OXFORDSHIRE
STRATEGIC RAIL FREIGHT INTERCHANGE

Chapter 3: Transport
Appendix 3.1: Transport Assessment Part 10 of 11

M40 J9 HIGHWAY DESIGN REVIEW

Project	**Oxfordshire Strategic Rail Freight Interchange (OxSRFI)**		
Document Number	OxSRFI-BWB-GEN-XX-RP-CH-0015	**BWB Ref**	NTH2479
Author	[redacted]	**Status**	S3
Checked		**Revision**	P01
Approved		**Date**	24.03.2026

FIGURE 1 – Location of problems identified in this audit

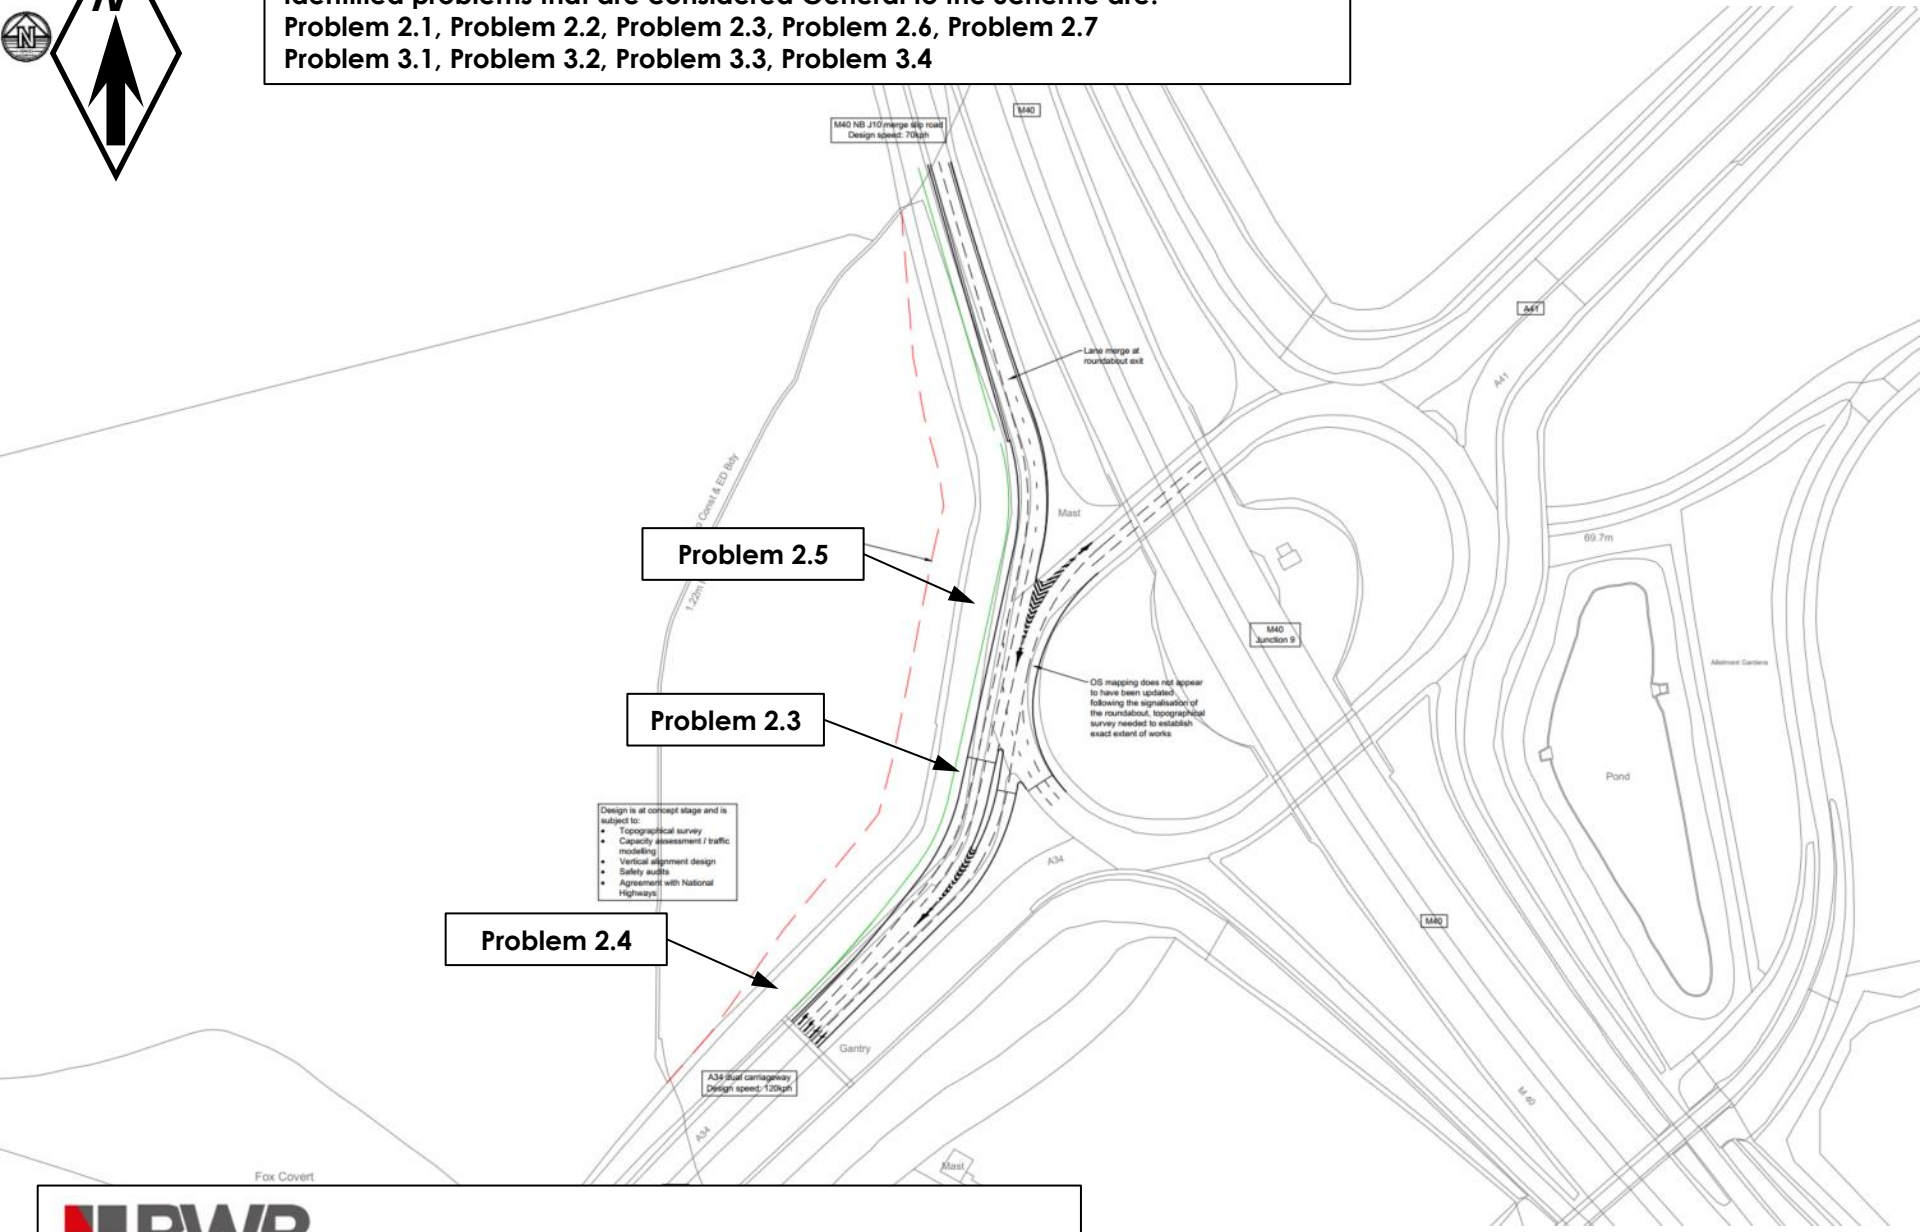
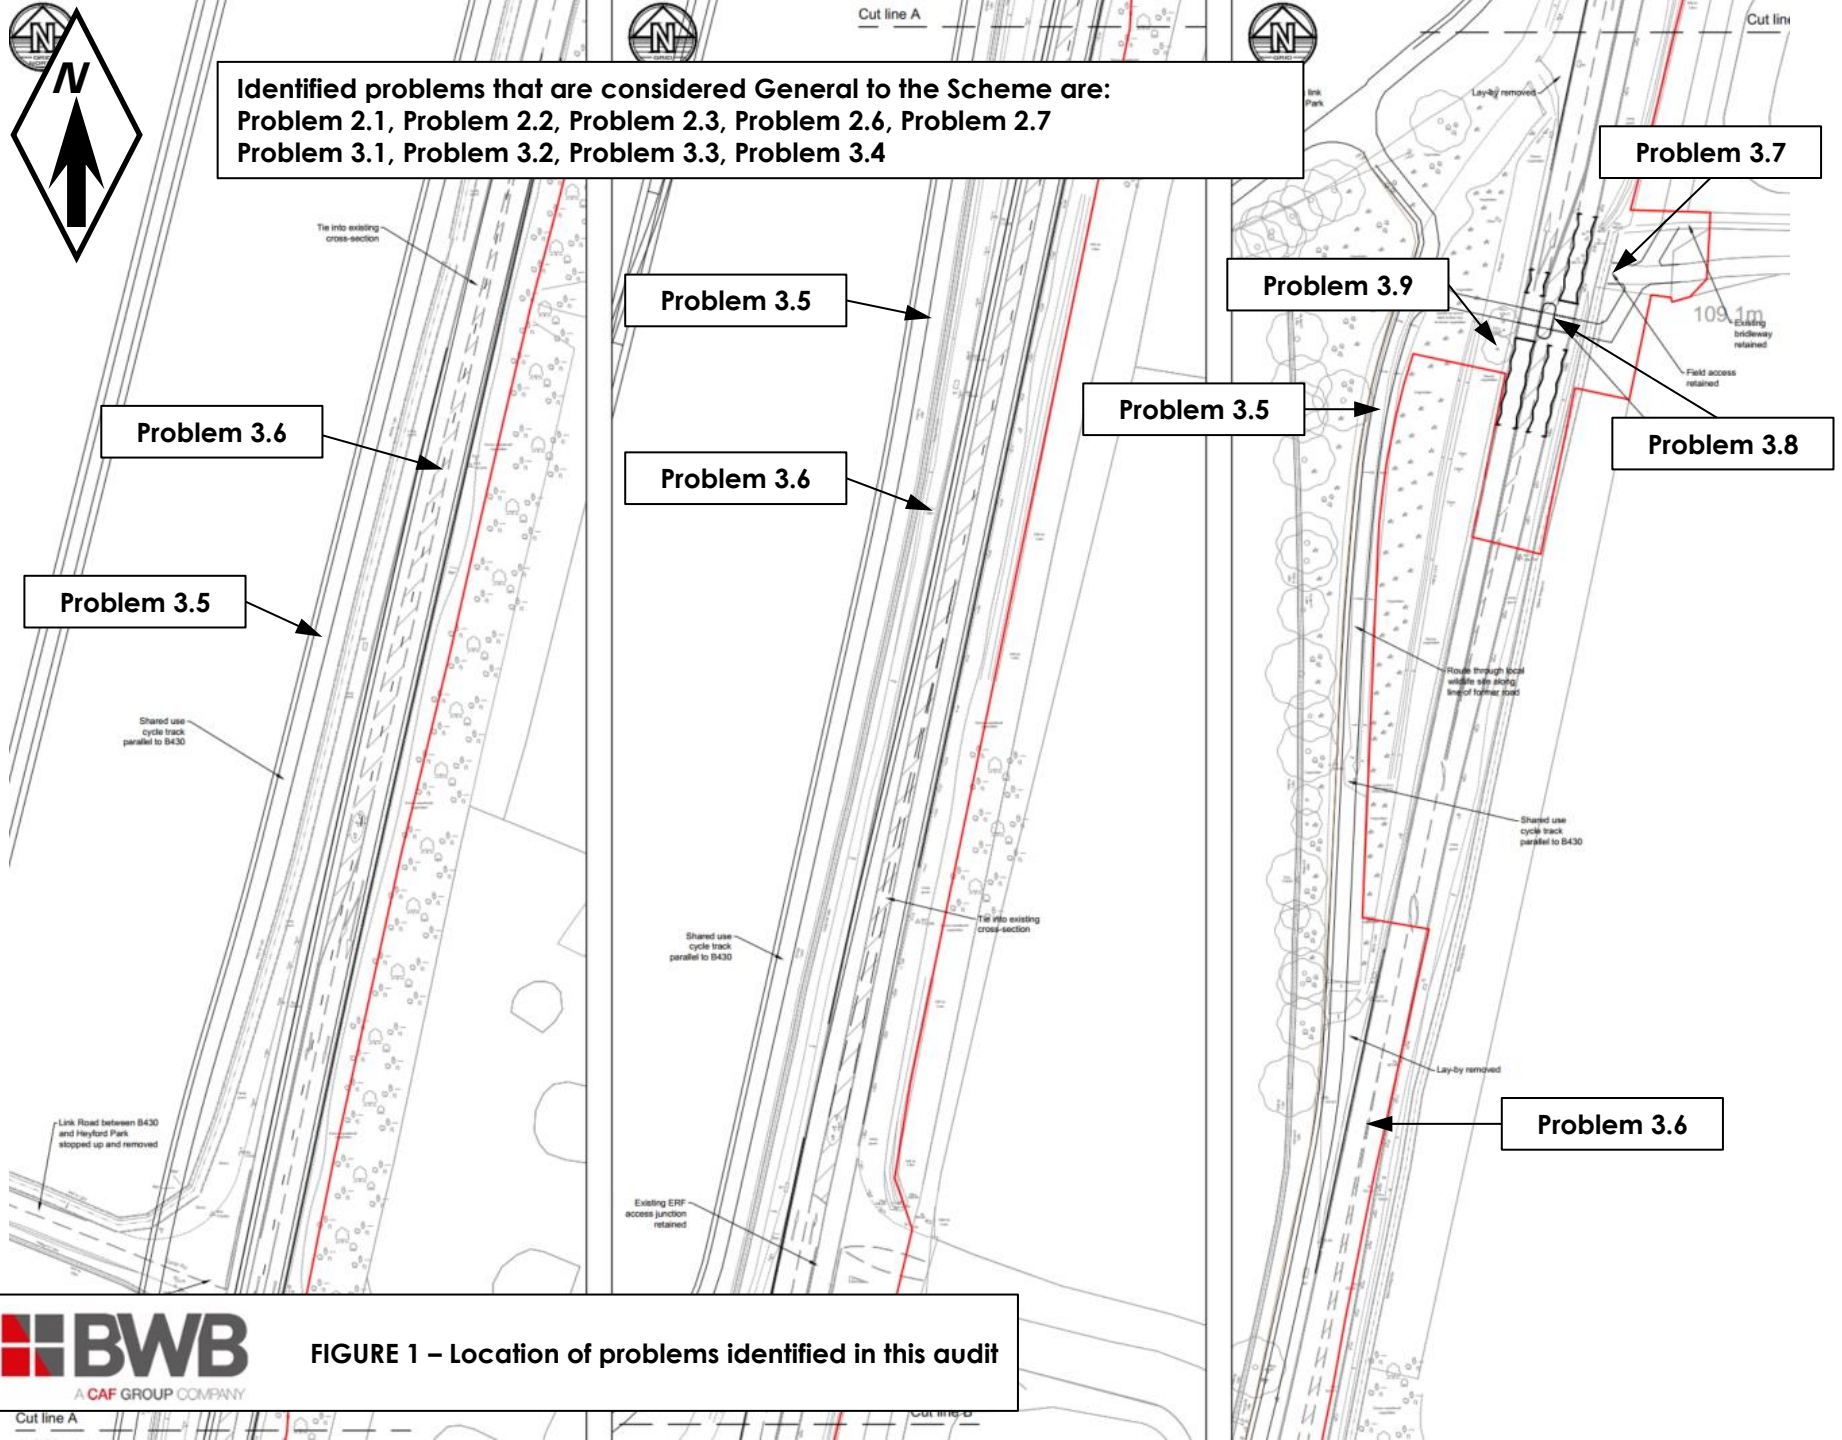
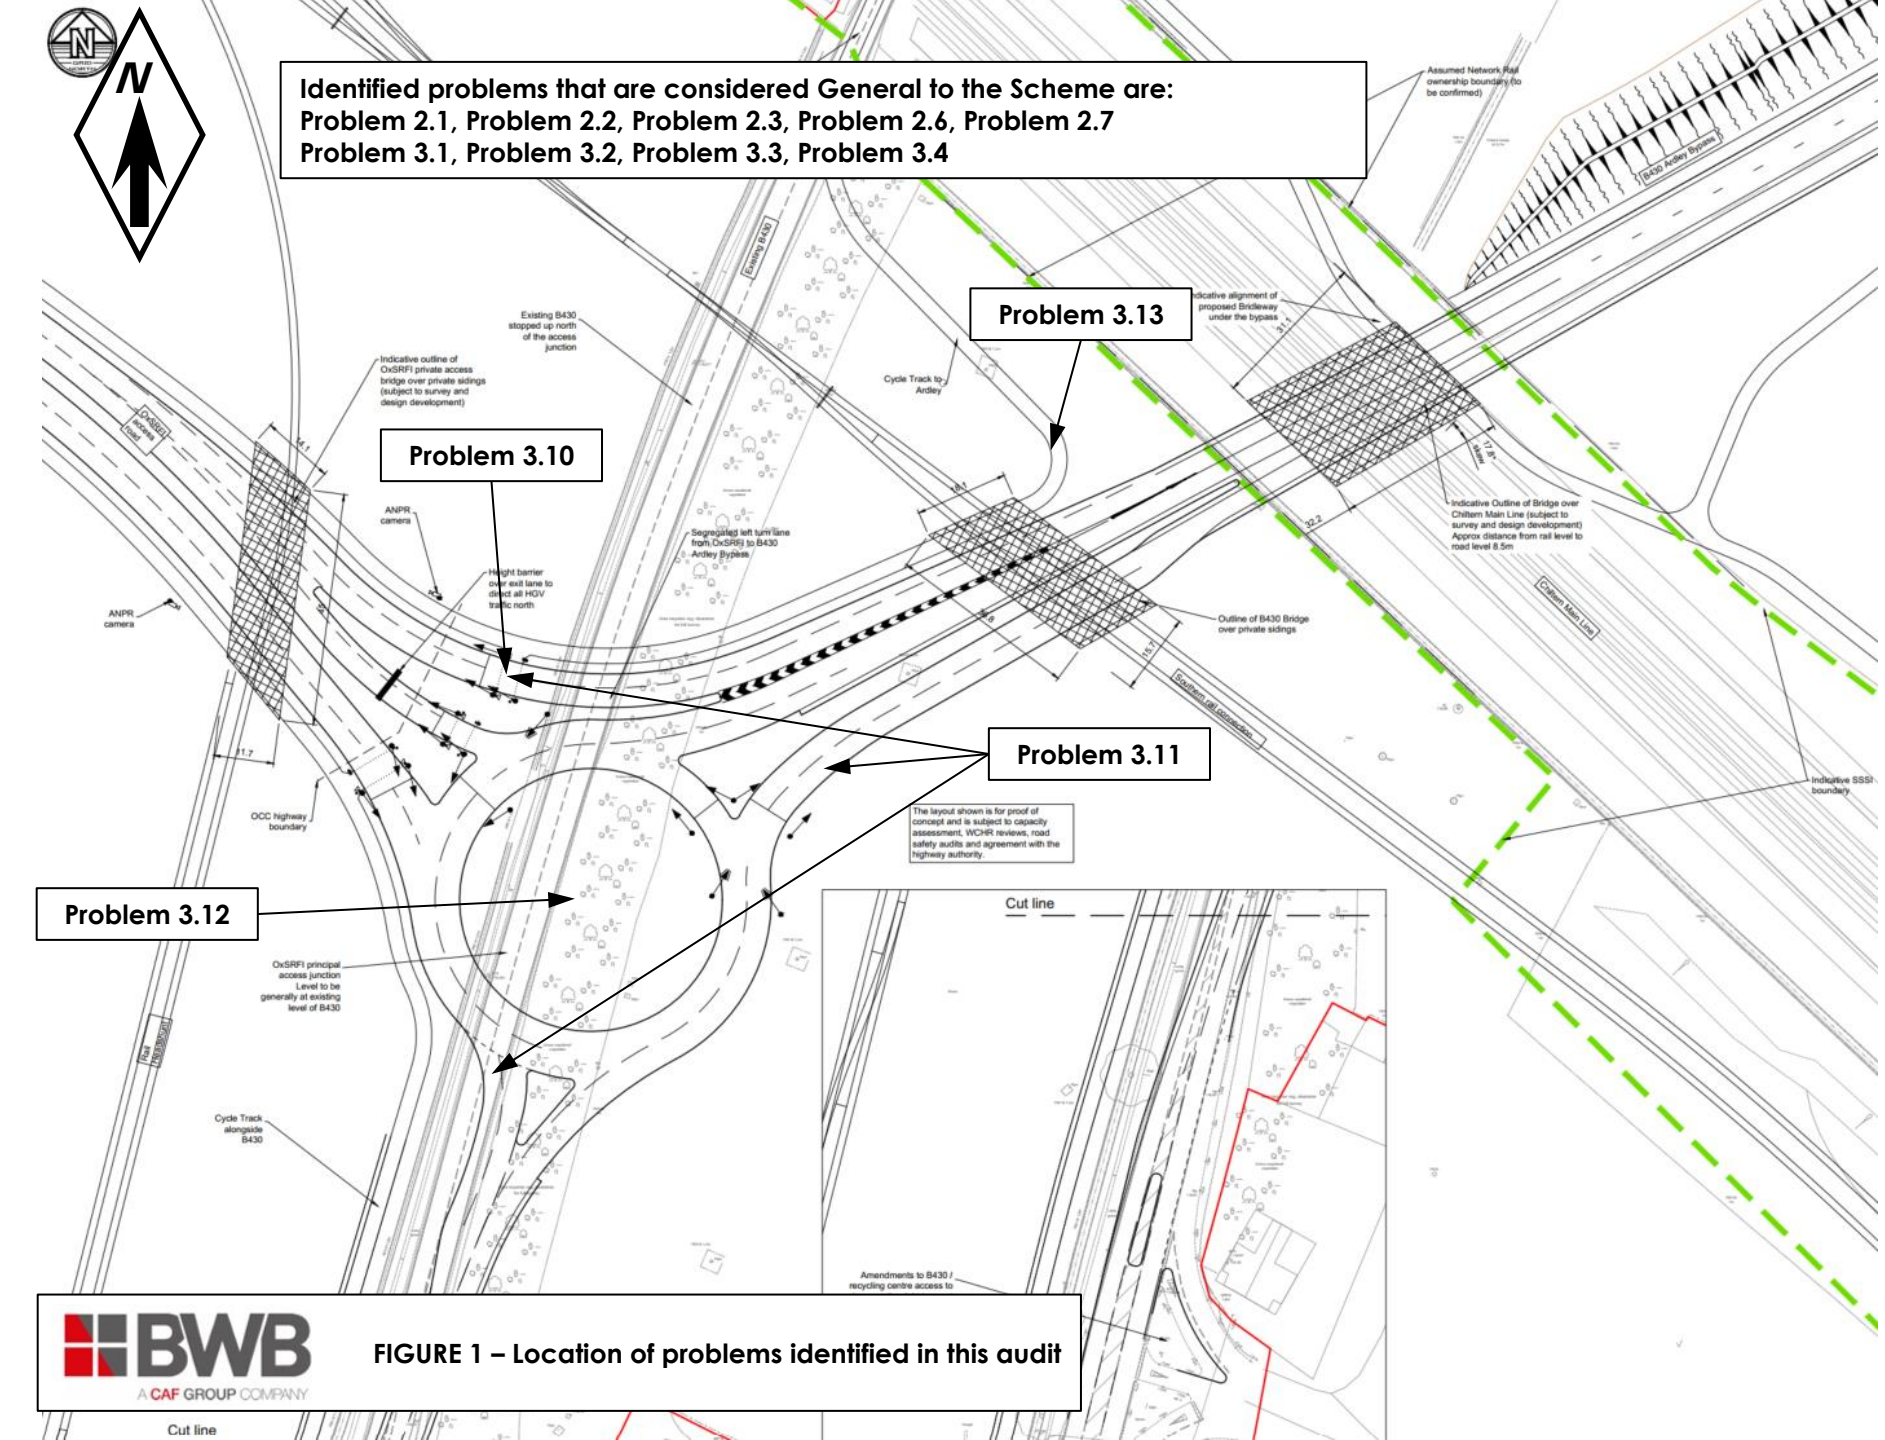
1.5 The terms of reference of the audit are as described in GG 119. The Audit Team has examined and reported only on the road safety implications of the scheme as presented and has not examined or verified the compliance of the designs to any other criteria. All comments and recommendations refer to the highway proposal drawings and the locations have been indicated on **Figure 1**.

Identified problems that are considered General to the Scheme are:
Problem 2.1, Problem 2.2, Problem 2.3, Problem 2.6, Problem 2.7
Problem 3.1, Problem 3.2, Problem 3.3, Problem 3.4

Problem 3.23
